Vickery Modification 1

People for the Plains object to Modification 1 of the Vickery project and request that the Modification is rejected.

Figure 5 | Revised Mine Plan and Goonbri Creek Alluvium

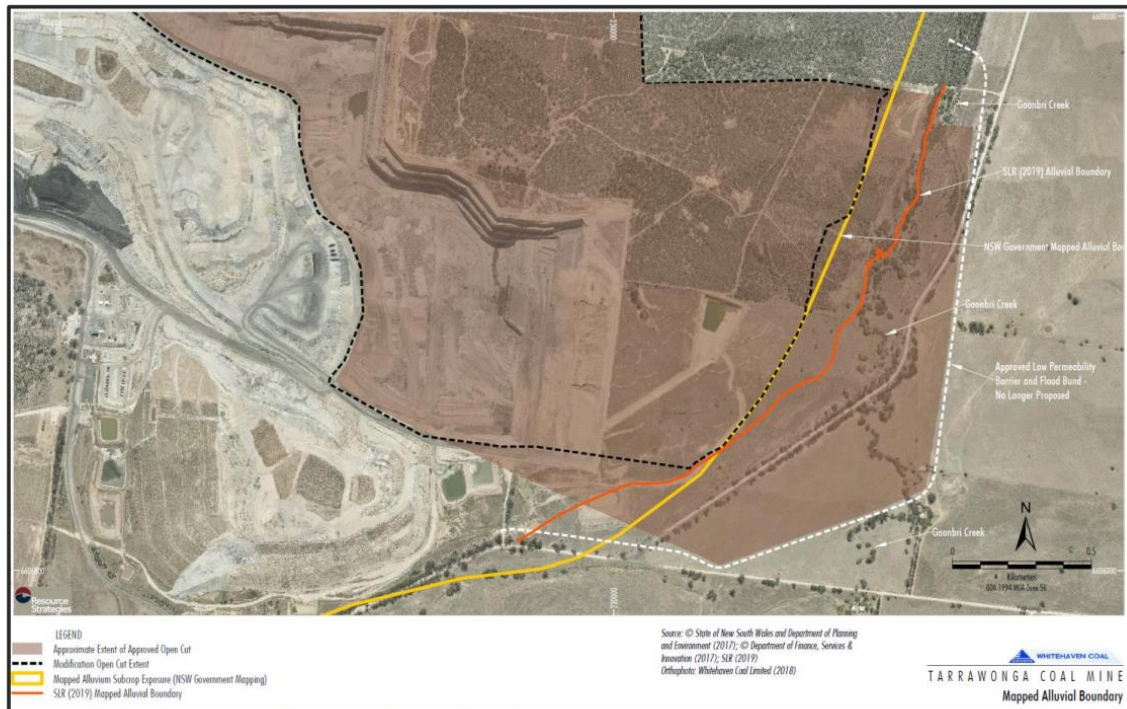
Instead of the low permeability barrier, Mod 7 requested a "flood bund" to stop water flowing out of the mine pit. Also of note that as part of this justification of removing the barrier, the line on the map indicating the edge of the aquifer was also moved.

See below the orange line is where WHC says the alluvium line is, the yellow is where the NSW Government says the line is (and the original alluvium boundary can be seen [here](#))

and the black is where WHC want to mine the pit up to (note the places where the black line reaches or goes beyond the yellow line i.e. the places where mining goes beyond the edge of the alluvium according to the NSW Government).

Figure 3 - mapped extent of alluvium and pit crest (after People for the Plains, 2020)

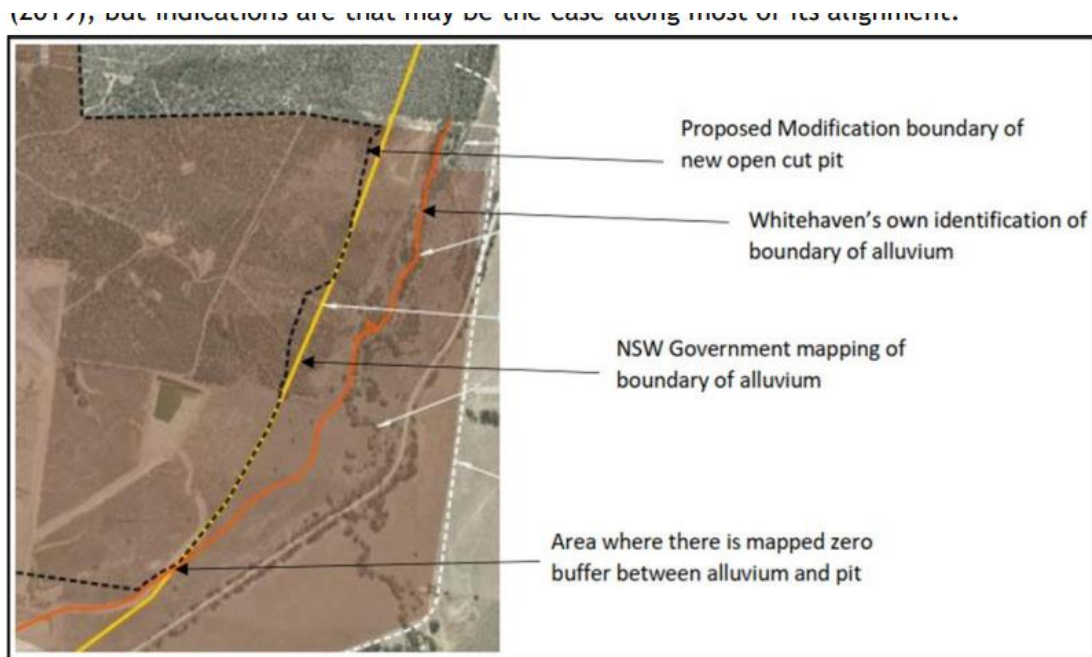
During the Tarrawonga Mod 7 application there were about 5 or 6 requests for more information from DPI Water with responses from WHC around the issue of removing the barrier from the plans and it included an [independent peer review](#) commissioned by the Department. Whilst this independent peer review “generally agrees the model is fit for purpose” it does note on page 10 the odd moving of the lines on the map:
